Re: Docket No. 516 – The United Illuminating Company Application for a Certificate of Environmental Compatibility and Public Need for the Fairfield to Congress Railroad Transmission Line 115-kV Rebuild Project

Enclosed for filing with the Connecticut Siting Council (“Council”) are The United Illuminating Company’s responses to the Fairfield Station Lofts, LLC’s September 14, 2023 interrogatories.

Attachment FSL-1-1

FSL - EXHIBIT 1A

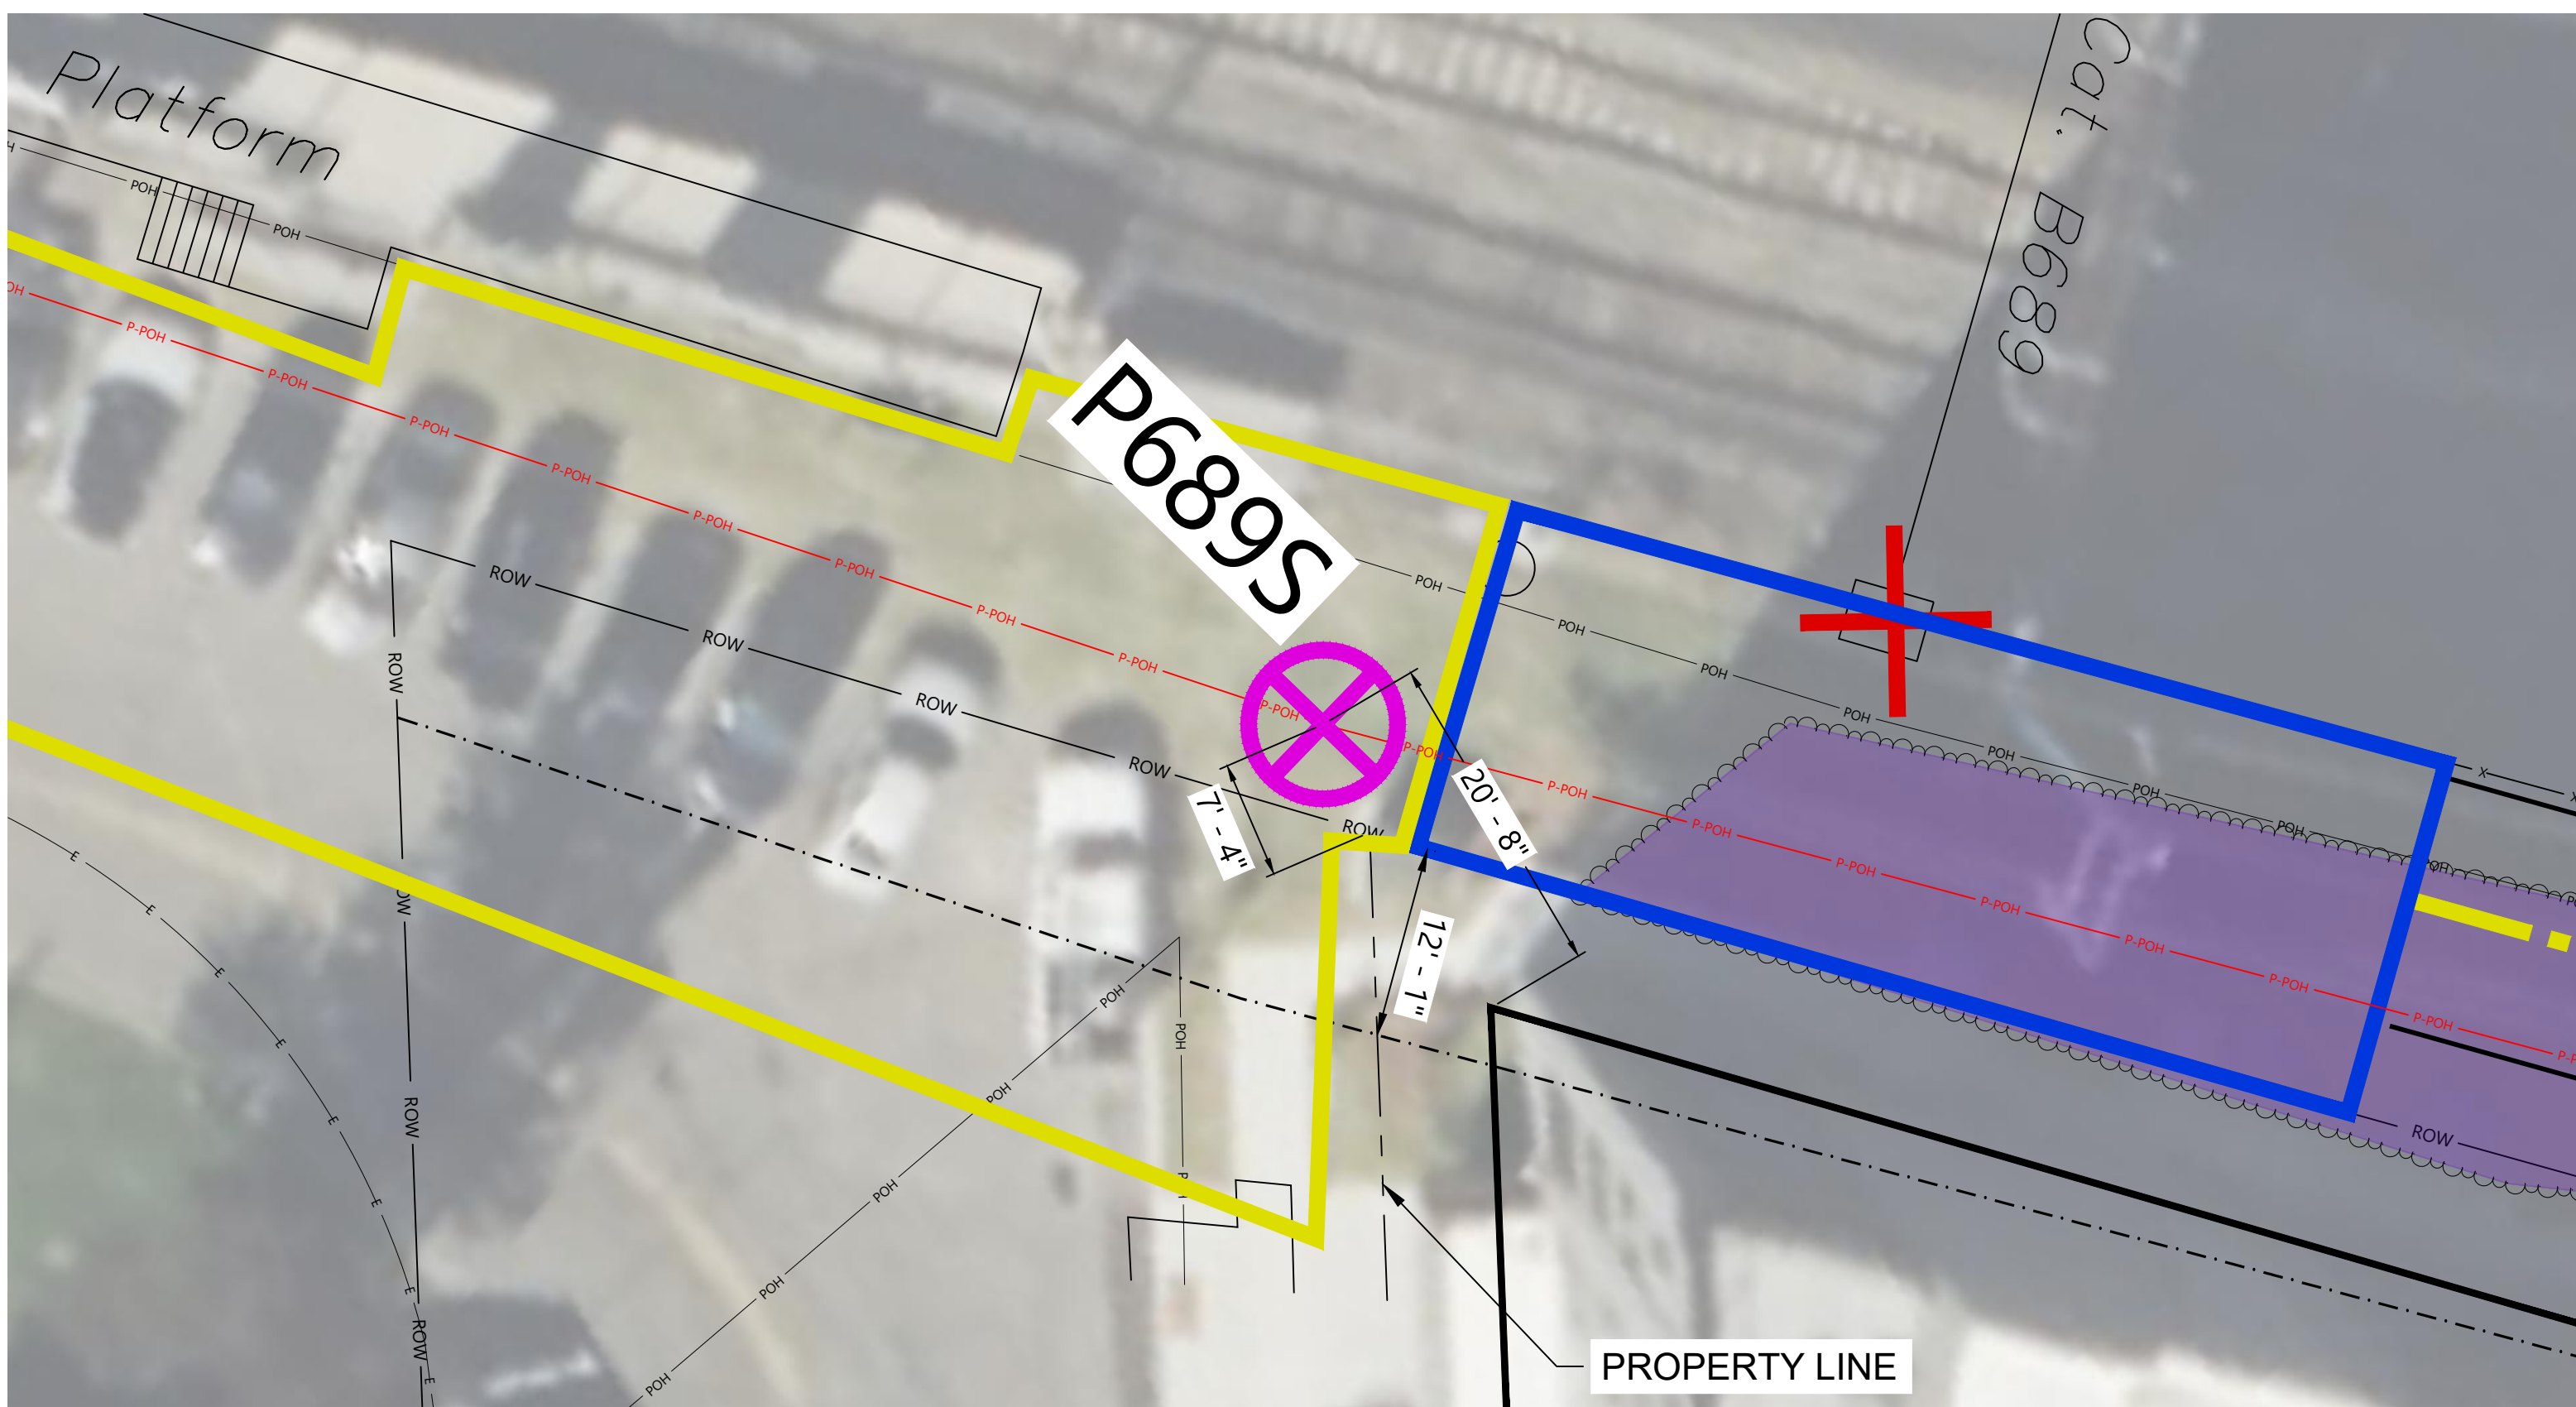
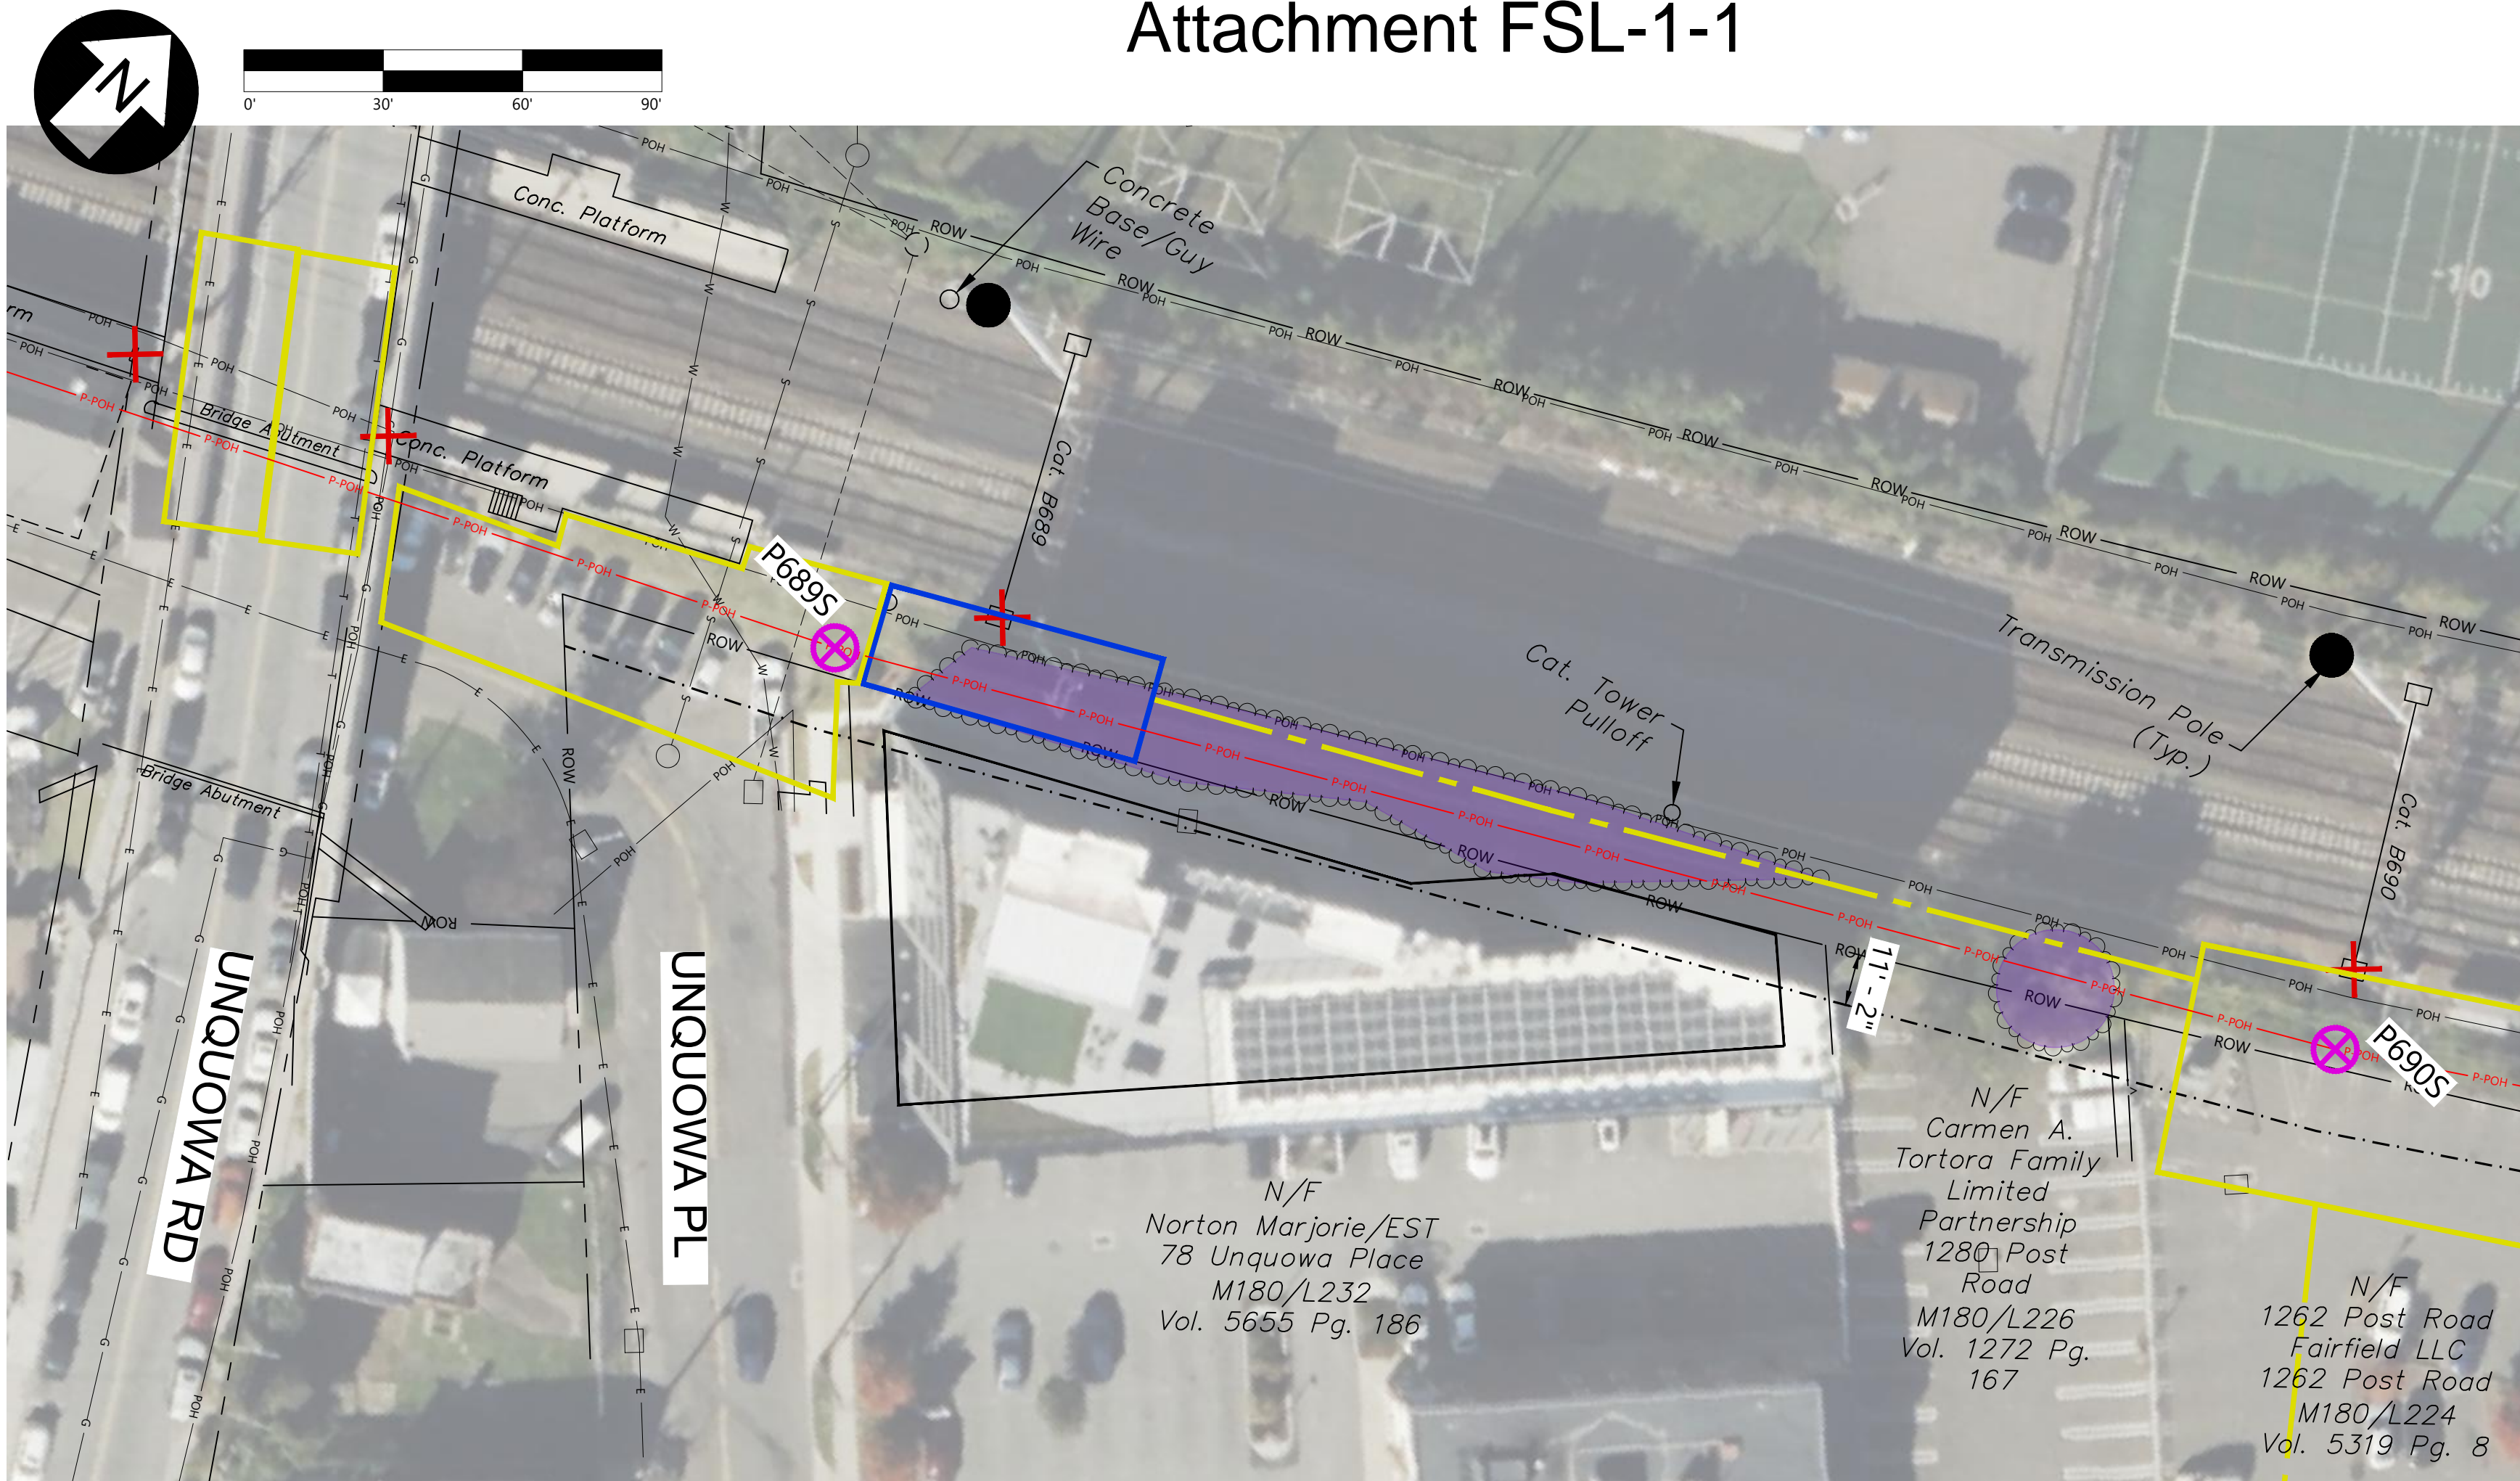
Q-FSL-3: Provide the precise location for proposed Tower P689S, including the precise location depicted on a survey with sufficient detail to understand the proximity of the proposed Tower P689S to property SAS-1754 and the actual distance from Tower P689S to the nearest portion of the Fairfield Apartment Building.

Q-FSL-16: In connection with the proposed work pad related to proposed Tower P689S:

- a. Describe in detail the nature of this work pad, including the activities that will take place in the work pad area, expected duration of this work pad area, and any restrictions that will impact adjacent areas (e.g., the Fairfield Apartment Building) as a result of the activities in and around the work pad area.

- b. Does this work pad extend onto property SAS-1754? If so, where and for what purpose?
- c. Will this work pad be secured with fencing or other perimeter control measures?

- d. Can this work pad be reduced in size or moved away from the Fairfield Apartment Building to avoid impacting the SAS-1754 parcel and building?
- e. When designing this work pad, including its location and size, did UI evaluate whether the location and size of the work pad would impede residents' access to the Fairfield Apartment Building or the ability of emergency services to access the westerly side of the Fairfield Apartment Building?

A-FSL-3: See Attachment FSL-1-1 for more information. In the application, the proposed location of Structure P689S is approximately 7'-4" away from the property line of SAS-1754 and 20'-8" away from the apartment building. The revised location of Structure P689S is approximately 23'-6" away from the property line of SAS-1754 and 36'-3" away from the apartment building.

- A-FSL-16:
- a. See Note 3 in Attachment FSL-1-1, Exhibits 1A and 1B.
 - b. The work pad does not extend onto property SAS-1754.
 - c. No. The work pad that is located in front of the apartment building will utilize the existing pavement. The work pad that is shown over the grassy area to the northwest of the building will consist of construction matting to allow for equipment access.
 - d. The work pad does not impact the SAS-1754 parcel. Further, for the revised design, the work pad will not impact the sidewalk located in public space on the west side of apartment building.
 - e. Yes. The work pad will not impede residents' access or emergency services to the Fairfield Apartment Building. The work pad in front of the building will utilize the existing paved area and work pads in the grassy area will utilize construction matting which is designed for use by construction equipment.

- PROPOSED POLE LOCATION:** THE ORIGINAL DESIGN IN THE APPLICATION PLACES THE POLE AND FOUNDATION FULLY ON THE CTDOT RAILROAD CORRIDOR, 7' - 4" FROM THE CORNER OF THE FSL PROPERTY AND 20' - 8" FROM THE CORNER OF THE APARTMENT BUILDING.
